SERVICE BULLETIN

HF-380 TRANSCEIVER (622-3580-001)
KWM-380 TRANSCEIVER (622-5093-001)
RECEIVER-EXCITER CIRCUIT CARD A3 (638-6908-002)

SERVICE BULLETIN NO 18

ELIMINATE RF POWER BURST WHEN UNKEYING TRANSCEIVER

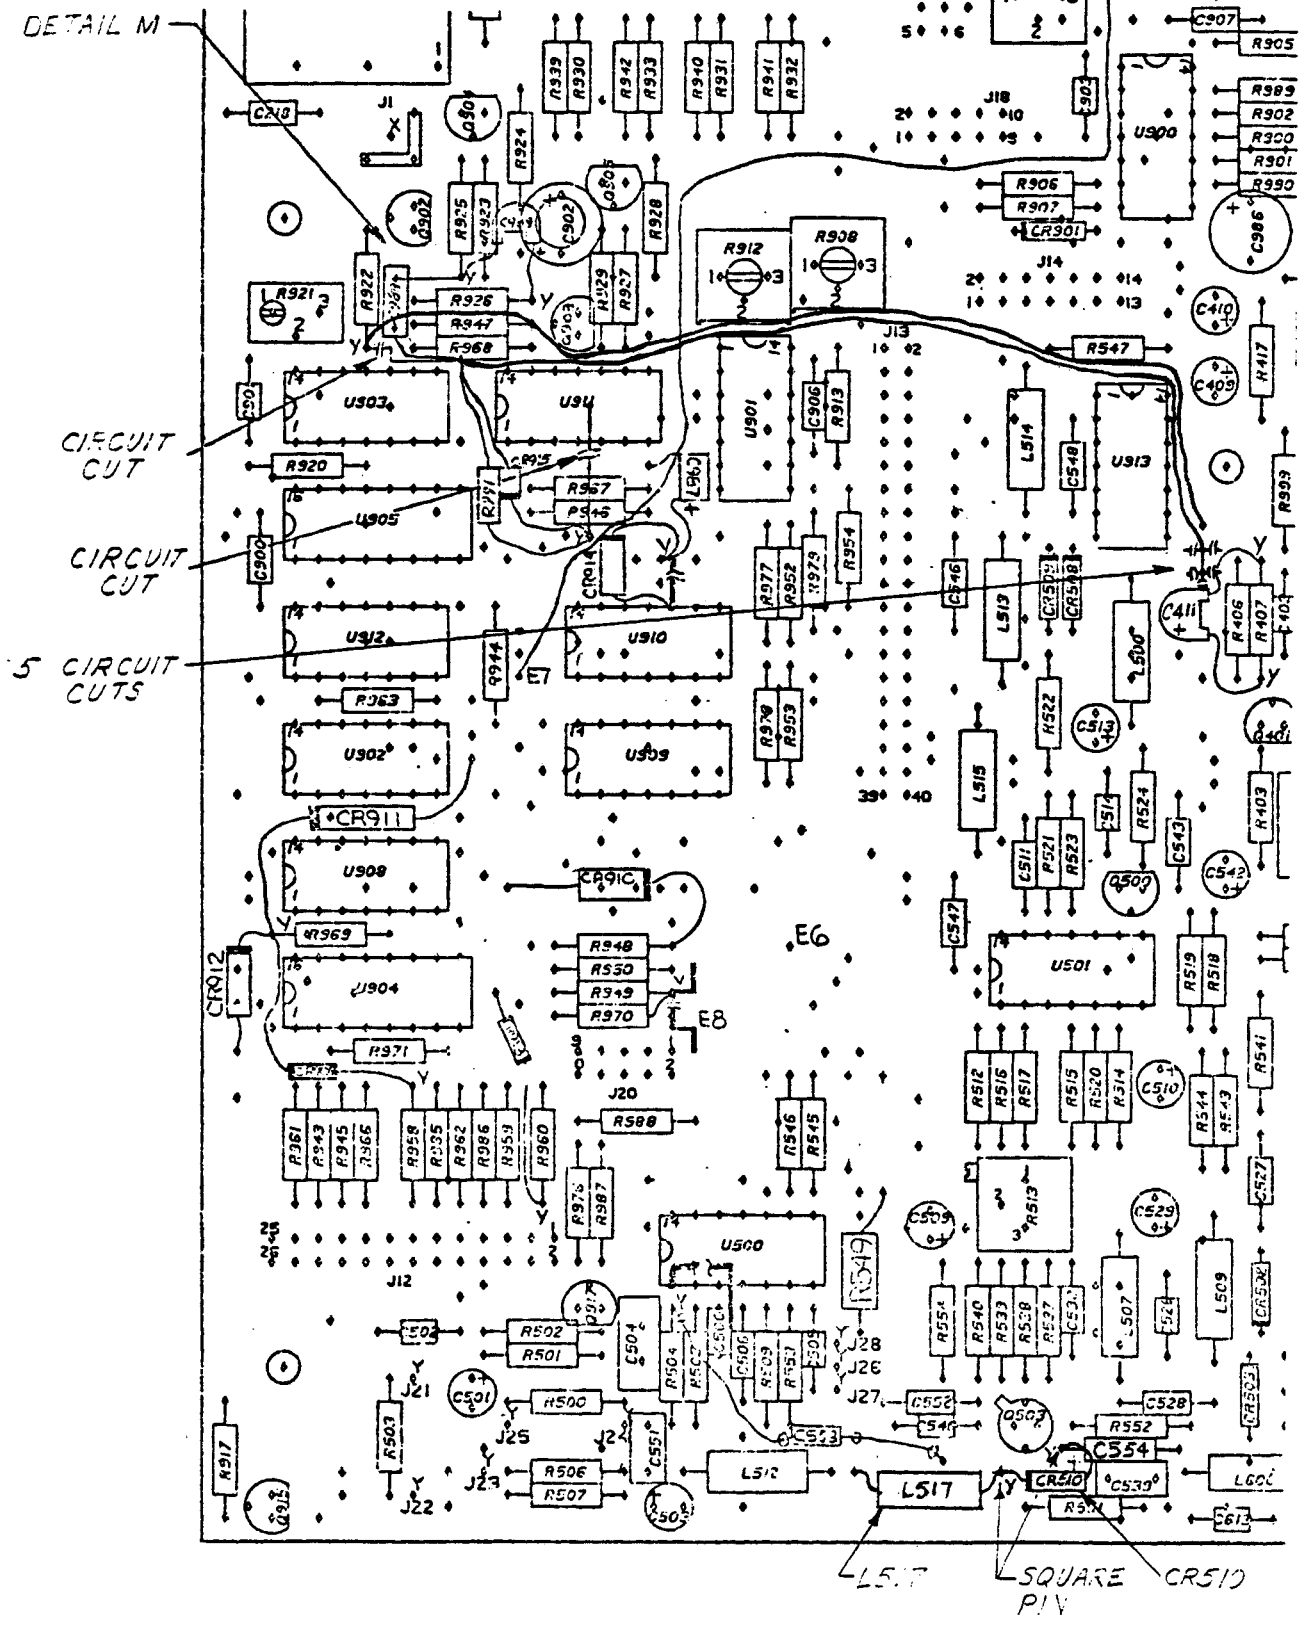
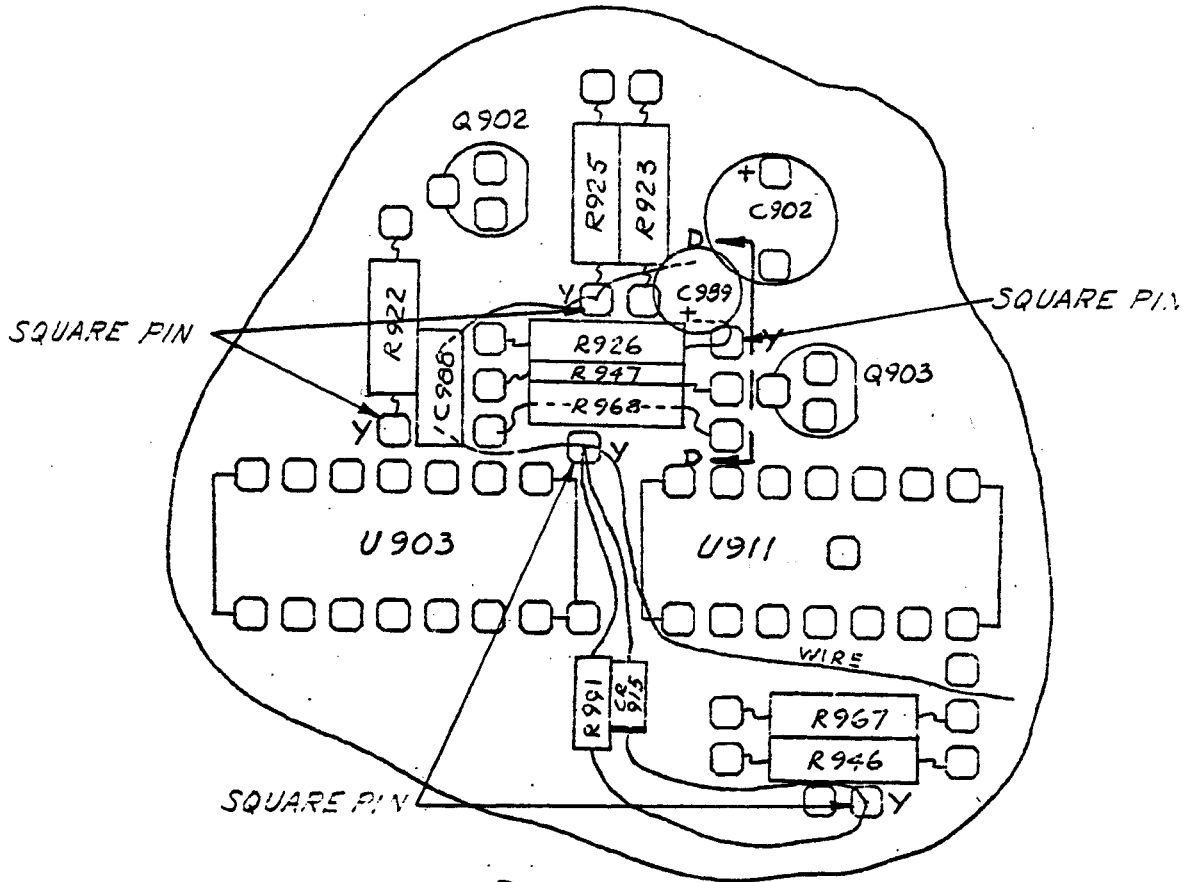
NOTE: All changes are made to the receiver-exciter circuit card A3, located on the bottom of the transceiver. Taking care to not damage adjacent components, these modifications can be made without removing A3 from the chassis. Refer to figure 1 for location of components. Refer to figure 2 for a schematic diagram which includes the changes made by this service bulletin.

P/O Receiver-Exciter Circuit Card A3.
Figure 1 (Sheet 2)

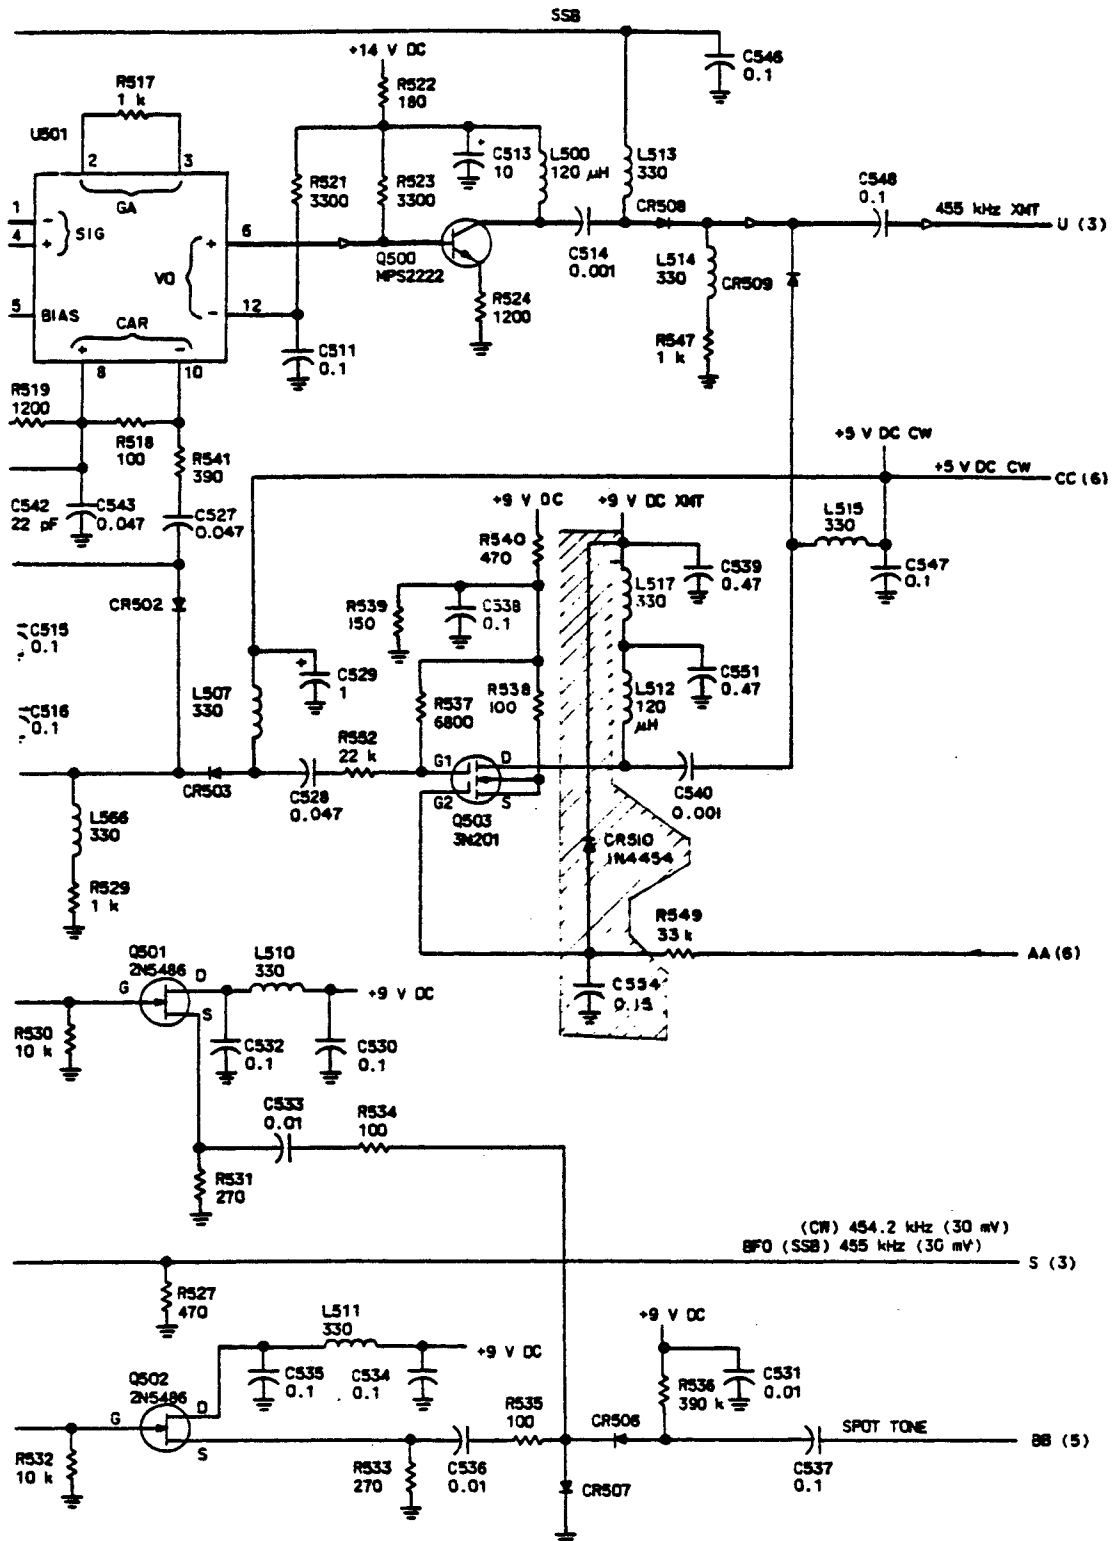
- D. Cut the circuit trace just below U911 to disconnect U910-8 from R922.
- E. Cut the circuit trace to the right of R922 to disconnect R922 from the rest of the circuit line.

- F. Make five circuit cuts near U913 to disconnect U913-8, -9 from ground. U913-8 and U913-9 will still be connected together.
- G. Remove and discard resistor R968. Mount a new 10-k Ω resistor R968 (745-0785-000) above R947 as shown in detail M, section DD, to make room for a square pin.

- H. Refer to figure 1, detail M, for location and install five square pins (372-2601-045). Lift component leads, as necessary, and reconnect the leads to the pins after the square pins are installed.

- I. Lift the right-hand lead of L517 and install a square pin (372-2601-045) in the hole vacated by the lead. Connect the L517 lead to the new square pin.

- J. Install 1N4454 diode CR510 (353-3644-010) with the cathode connected to the square pin at the right-hand lead of L517 and the anode connected to the square pin at the left-hand lead of C554.

- K. Install a jumper wire (428-0282-050) from the square pin at the bottom lead of R922 to the thru hole to the right of U913-9.

- L. Install a jumper wire (428-0282-050) from the square pin just below R968 to the thru hole to the right of U913-8.
- M. Remove 47- μ F capacitor C902 and replace it with a 10- μ F capacitor (184-9102-610).

- N. Install 0.1- μ F capacitor C988 (913-5019-440) from the square pin at the bottom lead of R925 to the square pin below R968.
- O. Install 1.5- μ F capacitor C989 (184-9102-800) with the positive lead connected to the square pin at the right-hand lead of R926 and the other lead connected to the square pin at the bottom of R925. Refer to figure 1, detail M, section D-D.

- P. Install 220-k Ω resistor R991 (745-0833-000) from the square pin below R968 to the square pin below R946.
- Q. Install 1N4454 diode CR915 (353-3644-010) with the anode to the square pin below R968 and the cathode to the square pin below R946.

P/O Receiver-Exciter Circuit Card A3,
Schematic Diagram
Figure 2 (Sheet 2)

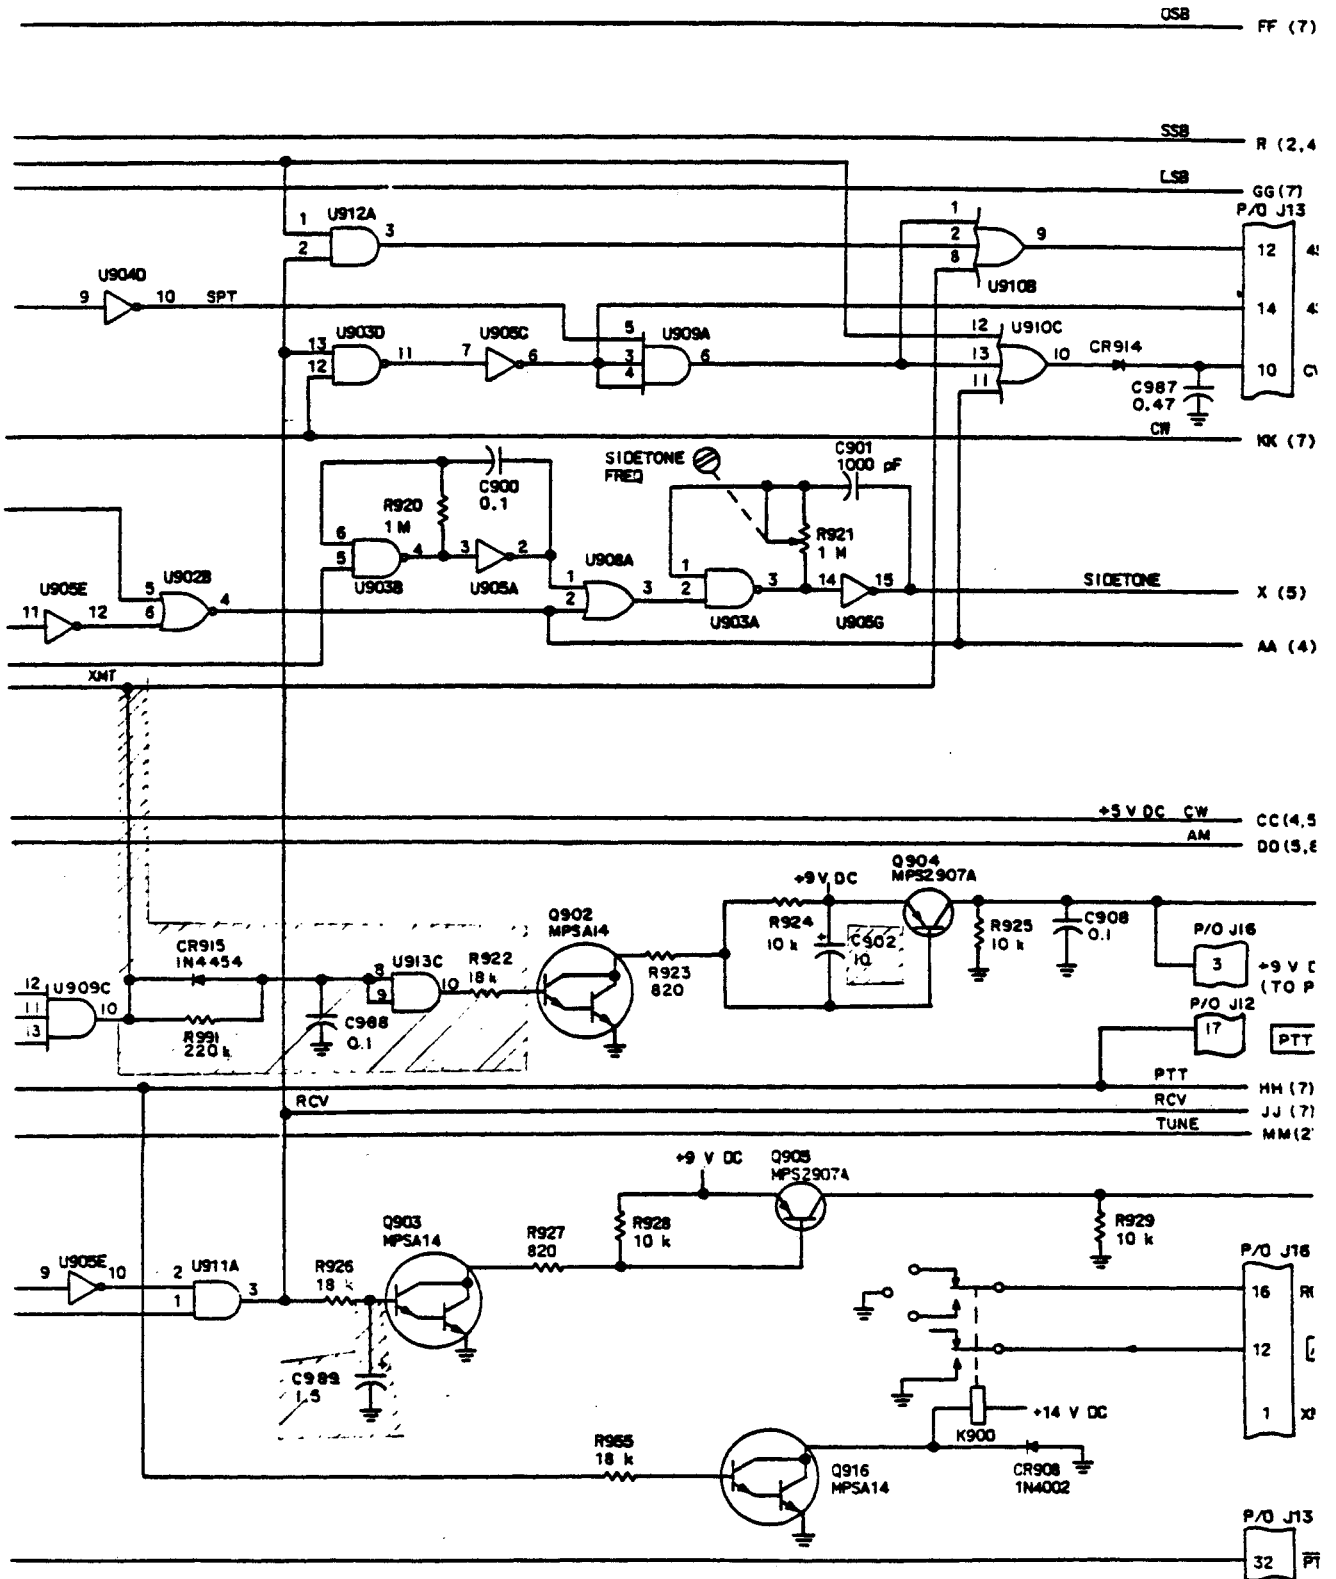
This modification eliminates the 2-ms rf power burst which occurs when the transceiver is unkeyed. It also increases the delay time to a nominal 20 ms between keying the transceiver and the start of rf output. This allows more time for an external linear amplifier relay to switch into transmit before rf is present.

The change consists of making seven circuit trace cuts; adding seven square pins, two jumper wires, two capacitors, one resistor, and two diodes; changing the value of two capacitors and one resistor.
